ASSESSMENT REPORT

WILPINJONG COAL MINE Pit Extensions and CHPP Optimisation Modification (05_0021 MOD 5)

Figure 3: Layout of Modification Proposal

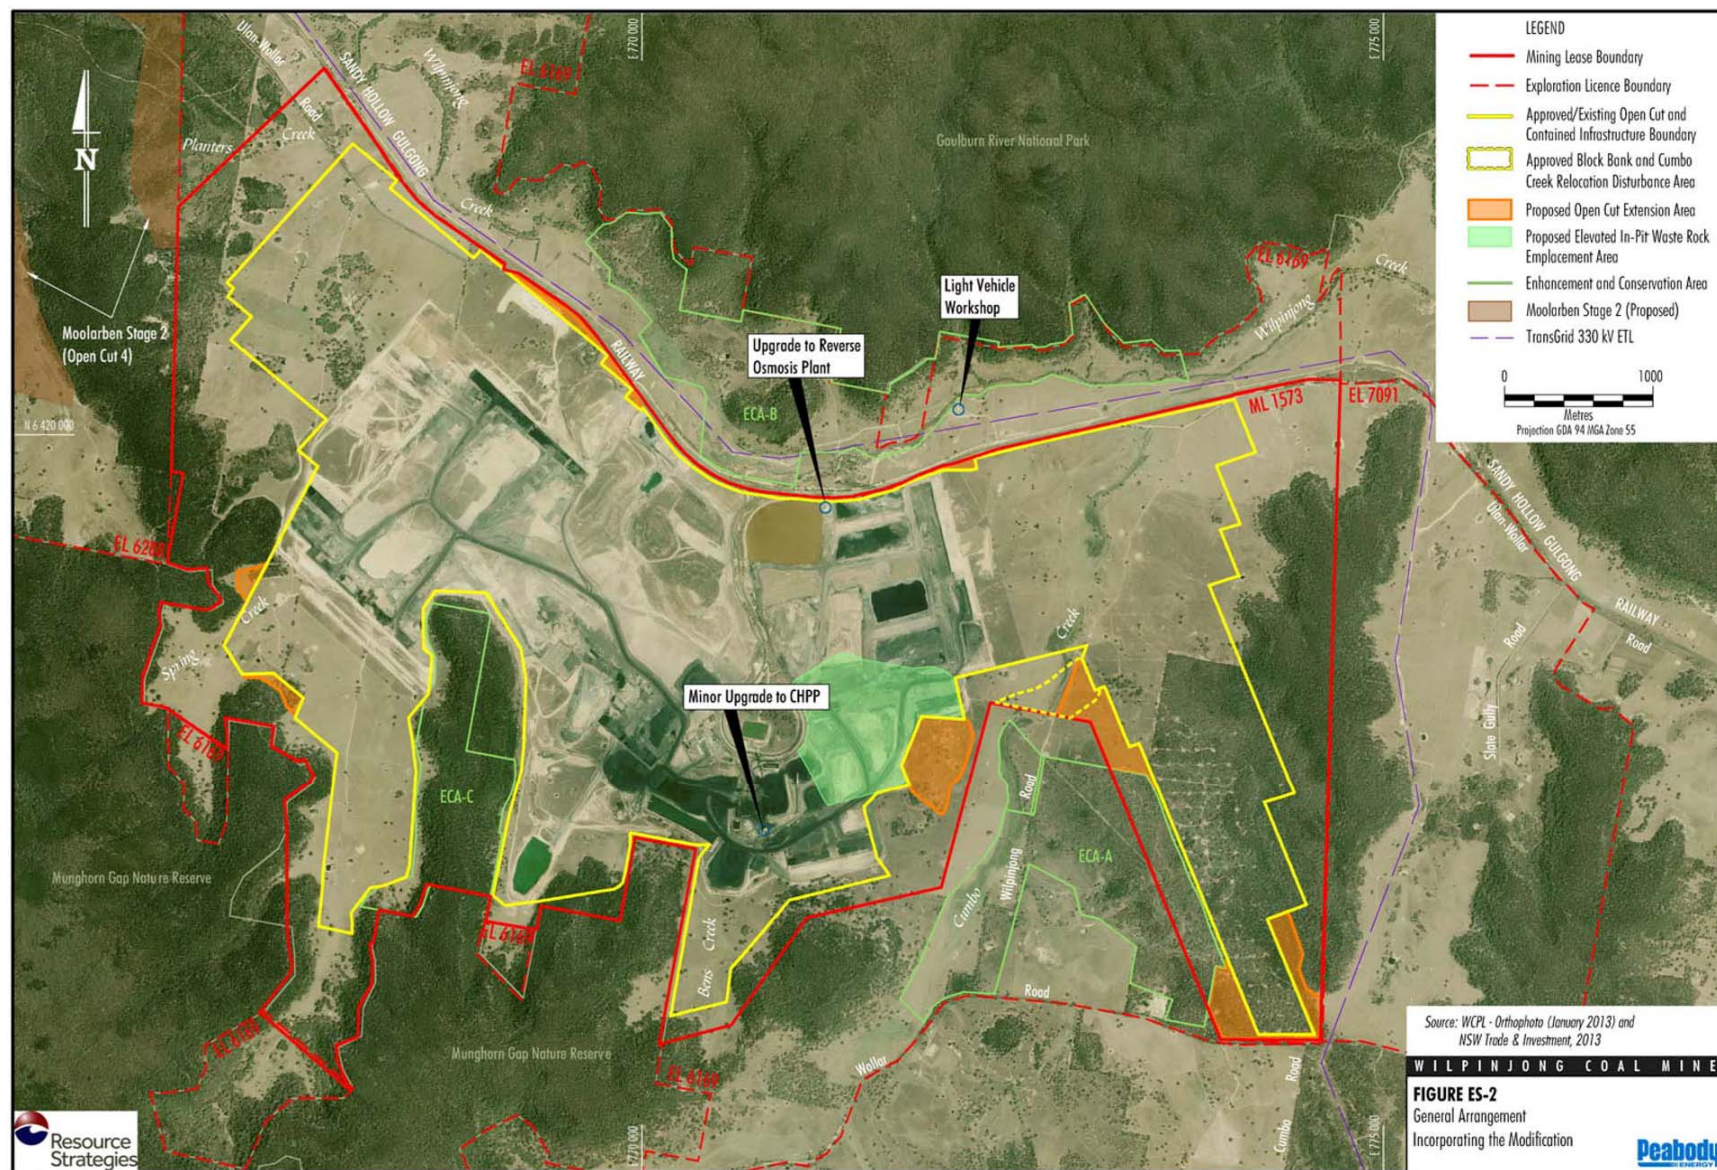
The proposed modification (see **Figure 3**) is described in detail in the attached Environmental Assessment (EA) (see **Appendix A**), and has 7 major components:

There are six extension areas in total, all comprising relatively small additions to the existing open cut pits. These areas are shown in orange in Figure 3.

WCPL proposes to place the additional waste rock in an elevated waste rock emplacement area in the southern end of Pit 2 (see the area shaded in light green on Figure 3). This emplacement area would be filled to a height of 450 metres (m) AHD before it is reshaped and lowered to 430 m AHD during the final rehabilitation of the mine.

Figure 4: Location of the Proposed Biodiversity Offset Areas

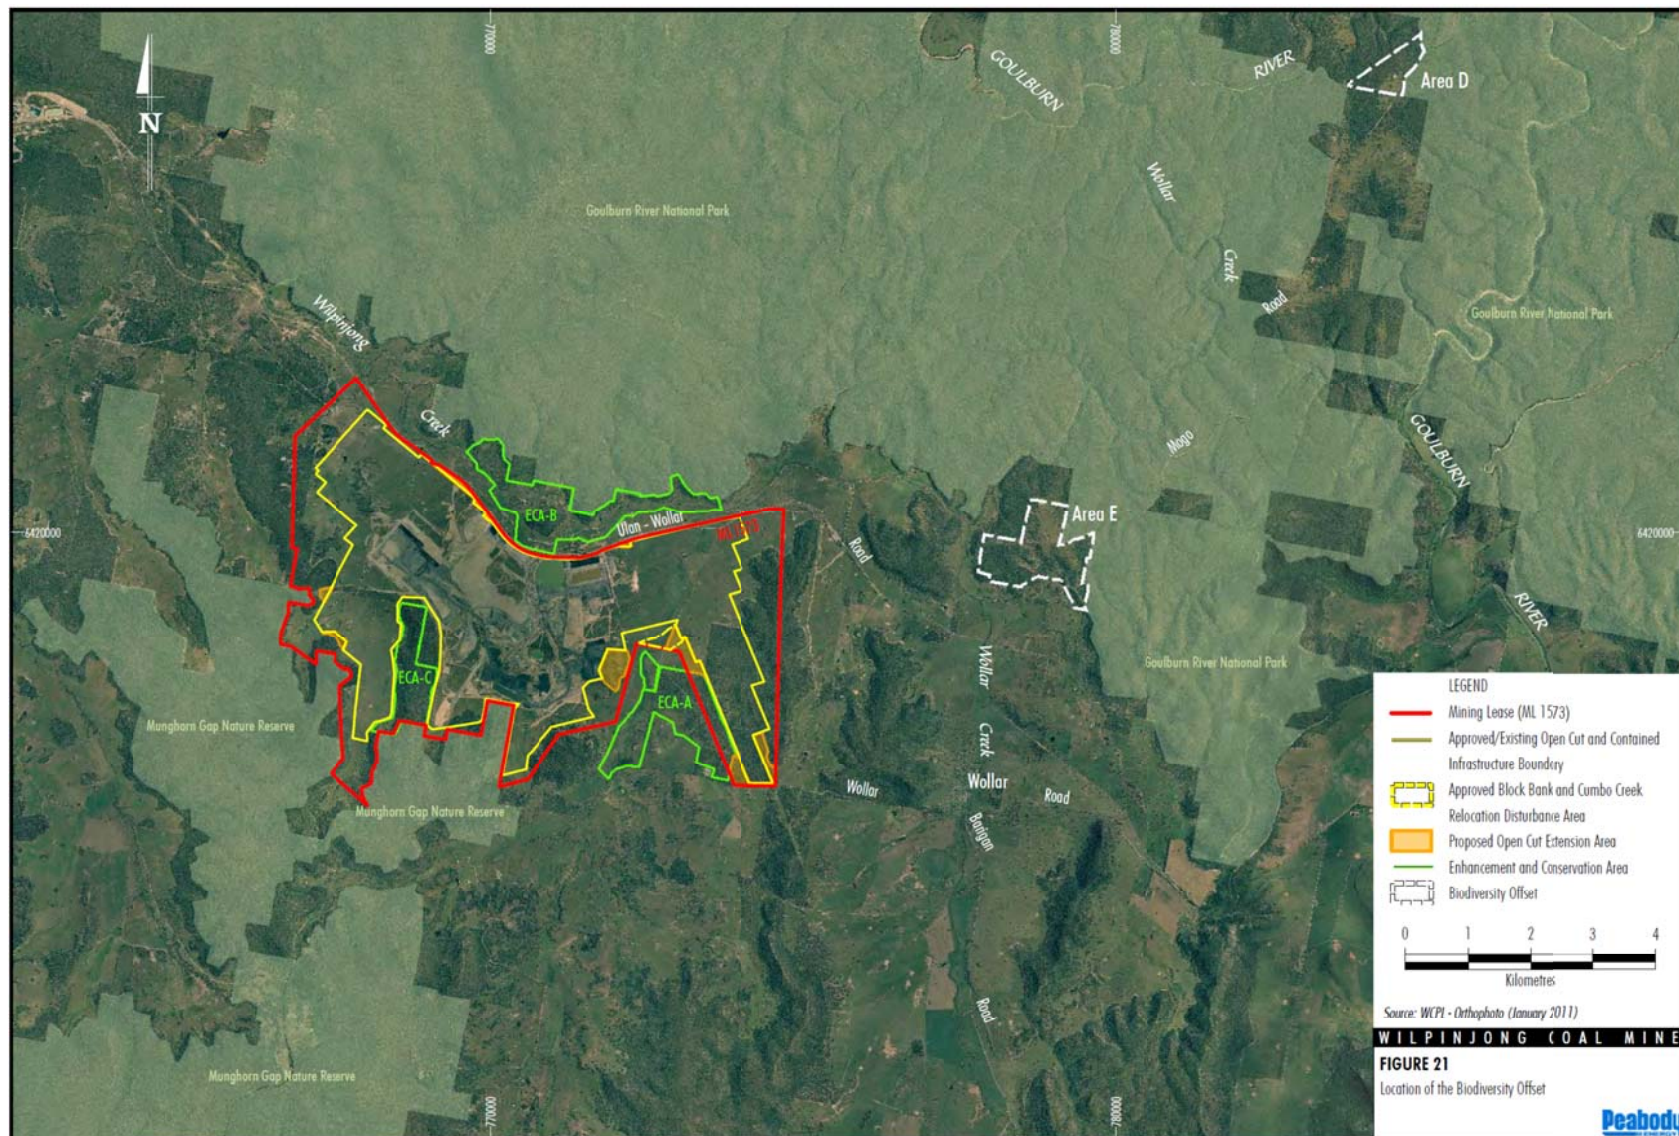
To offset the potential impacts of the proposal, WCPL proposes to permanently add two parcels of land, one located approximately 3 km east of the site and the and 12 km northeast of the site, to the adjoining Goulburn River National Park (see **Figure 4**).

Some objectors claimed this offset was inadequate. Nevertheless, both the Department and the OEH are satisfied that the proposed offset would result in a net improvement in the biodiversity value of the region, and would adequately offset any residual impacts of the proposal. This is primarily because the offset:

- has at least 47.8 hectares of existing Box Gum Woodland EEC, compared to the 2.2 hectares of woodland and 8.4 hectares of derived grassland that would be cleared, and probably includes additional areas of the EEC in grassland form (although these have been excluded from the EEC calculations to ensure they are conservative);
- has similar vegetation communities to those that would be cleared, which could be enhanced over time with suitable management;
- includes habitat or potential habitat for all the threatened fauna species recorded within or near the areas to be cleared; and
- is ideally located, adjacent to the Goulburn River National Park, and could easily be added to the national reserve system.

Consequently, the Department has recommended that WCPL be required to implement the proposed offset strategy, and use its best endeavours to add this land to the National Park.
